Road Department

ADDENDUM NO. 1

CONSTRUCTION OF THE POWELL BUTTE HIGHWAY ROUNDABOUT

DYNAMIC FEEDBACK
WARNING SIGN PLAN

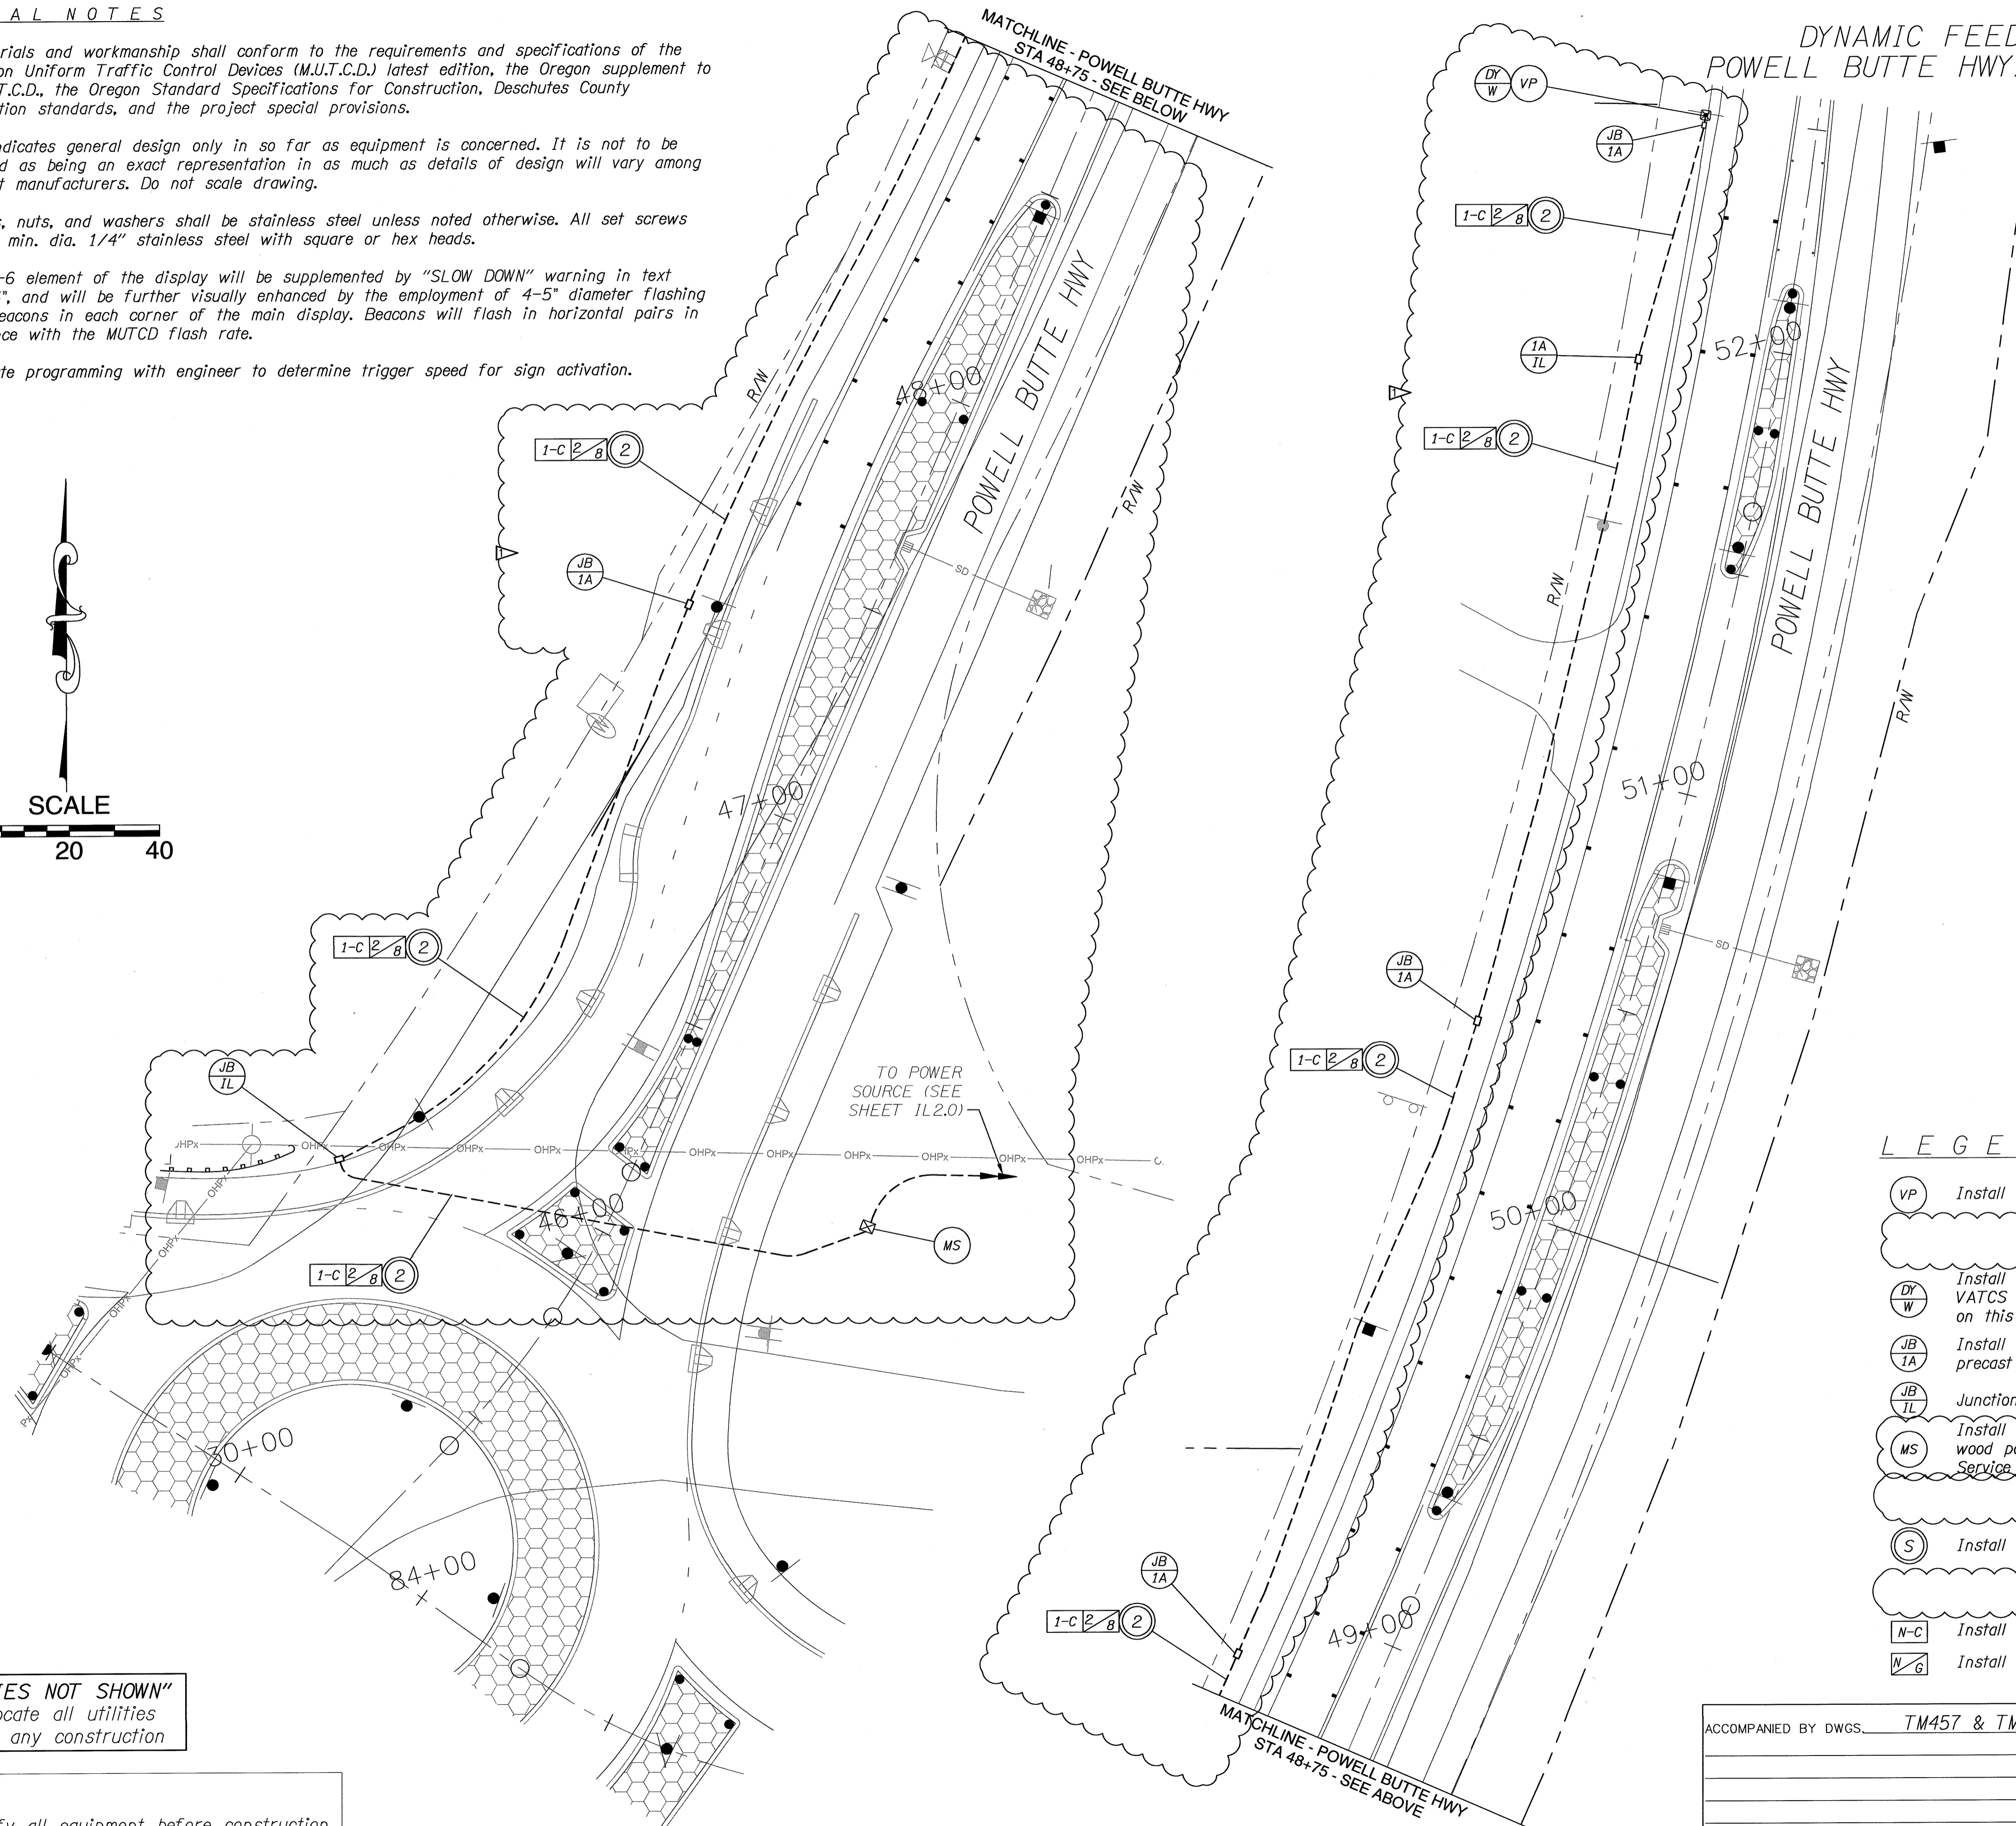
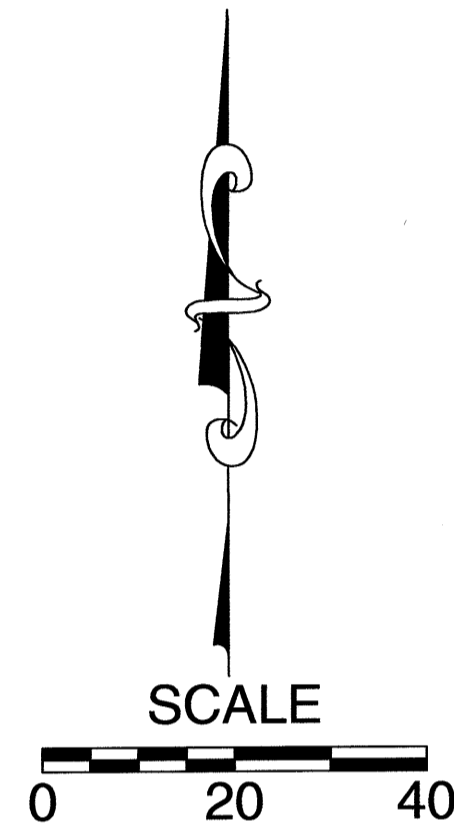
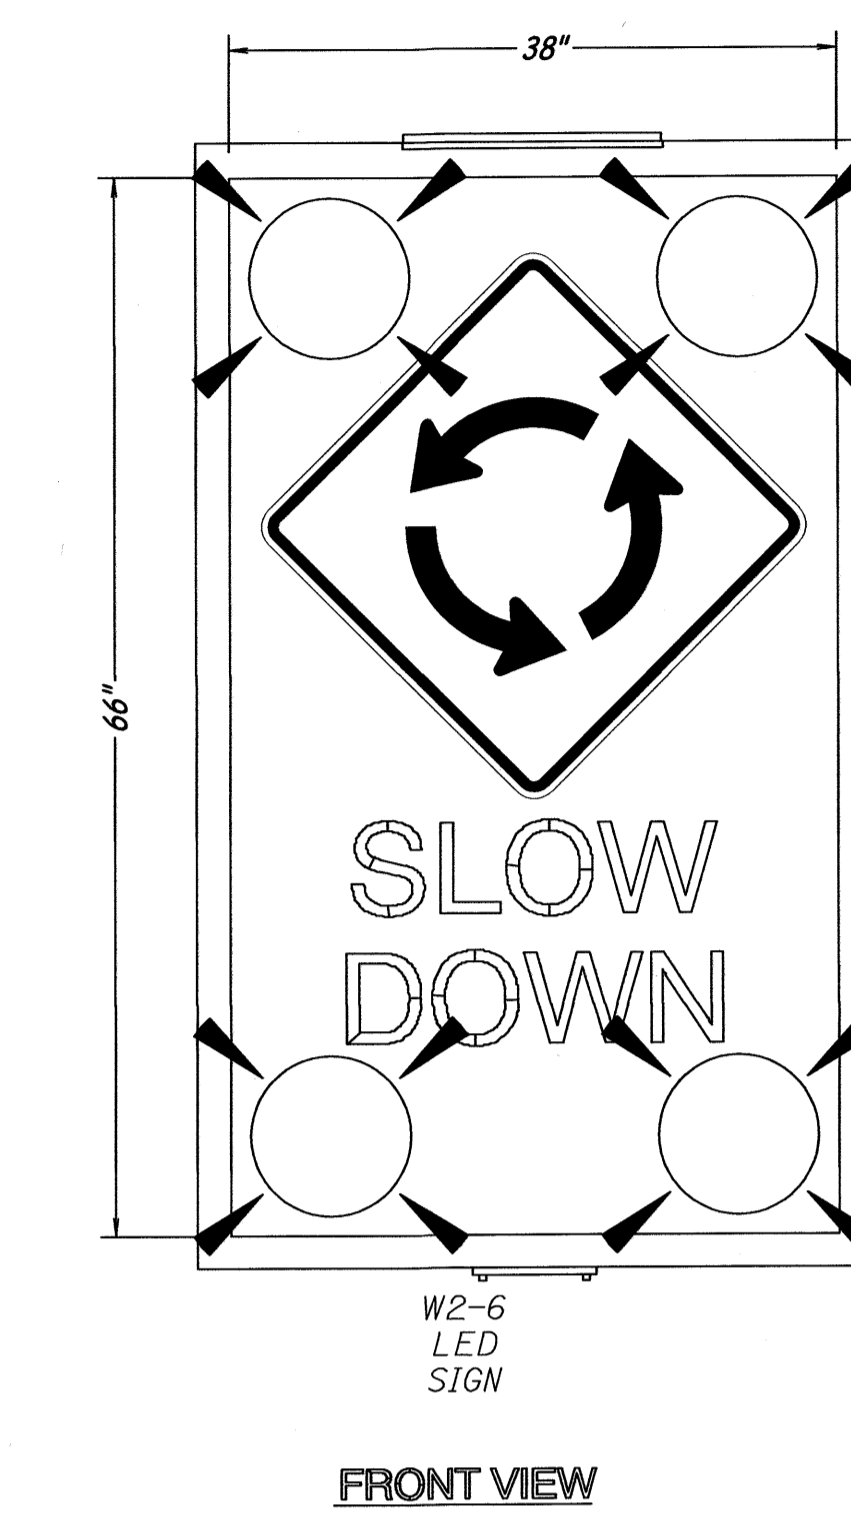
- a. The scale bar has been corrected. See revised sheet in plan addendum.
- b. The conduit layout has been updated to show the system as independent from the lighting system. See revised sheet in plan addendum.
- c. Additional detail has been provided for the metered service (MS) legend note. See revised sheet in plan addendum.
- d. The LP, SC/IL, and LC legend notes have been deleted as they are no longer referenced on this sheet.

NEW PEDESTAL SITE DETAIL

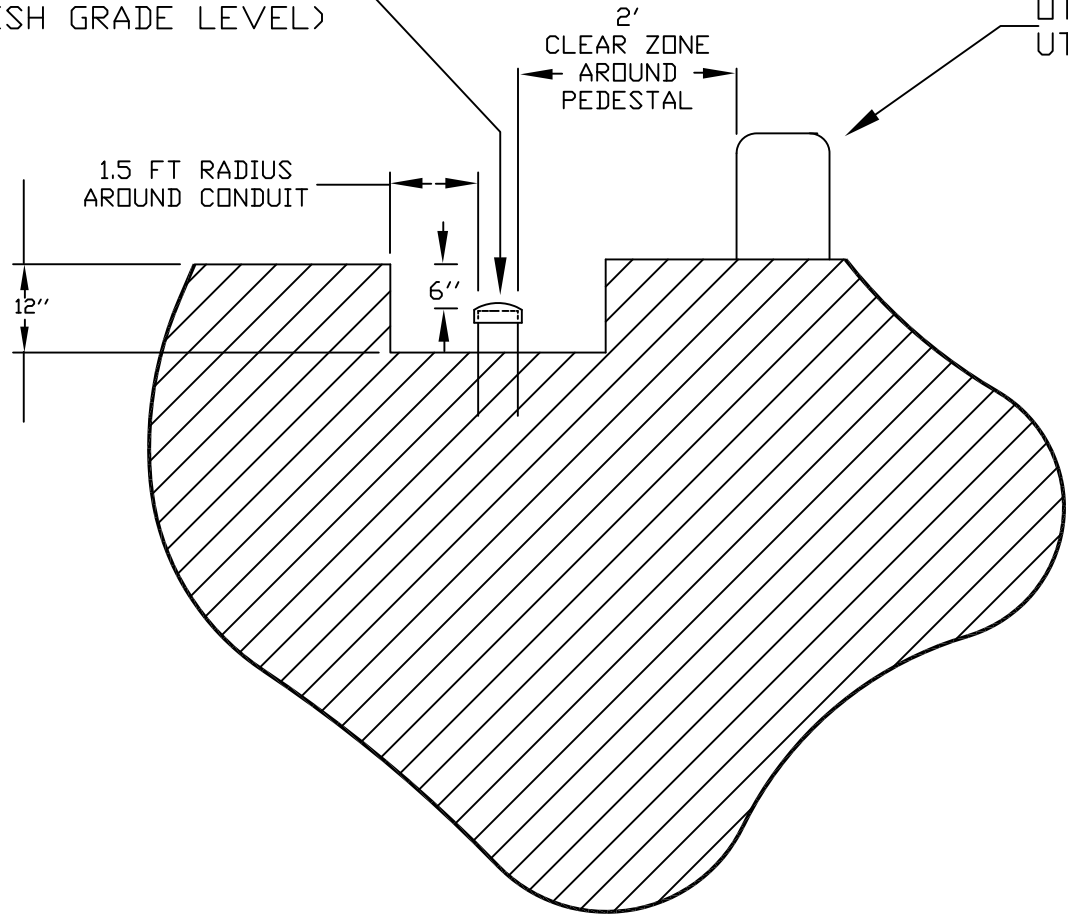
- d. A legend note for the pedestals (PED/N) has been added. See revised sheet in plan addendum. Detail referenced in note is included as an attachment to this addendum.
